City of Portland, Maine - Building or Use Permit Application
 389 Congress Street, 04101 Tel: (207) 874-8703, Fax: (207) 874-8716

| Permit No: 01-0545 | Issue Date: MAY 29 2001 | CBL: 051 A023001 |

BUILDING PERMIT REPORT

REASON FOR PERMIT: To Construct a 24'x26' attached 2 Car Private Garage

FRONT ELEVATION
Scale: N.T.S.

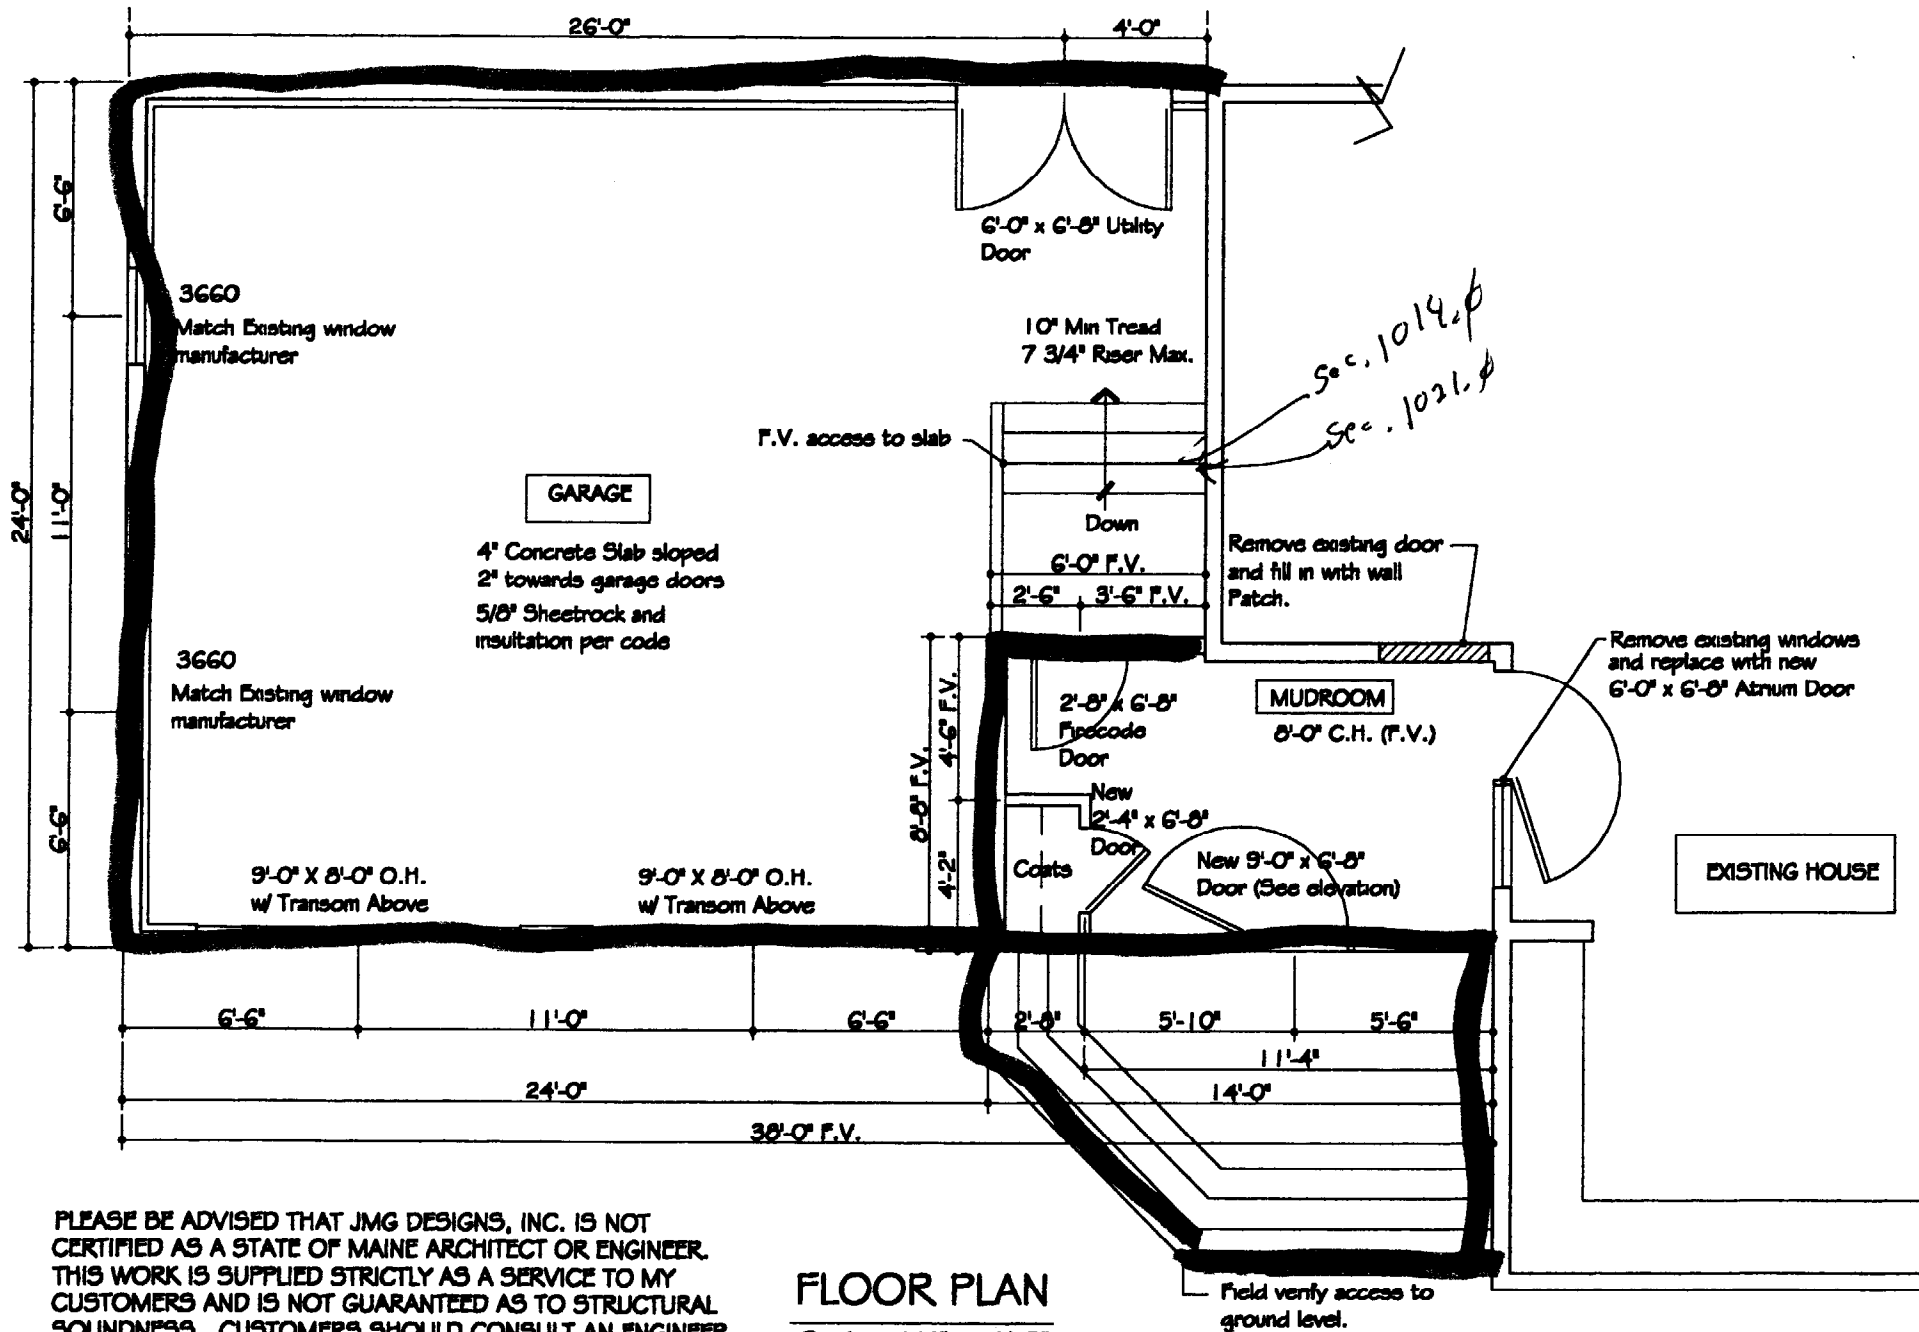
Stain Coors,
Sec. 1014.0

Handrails
Sec. 1022.0
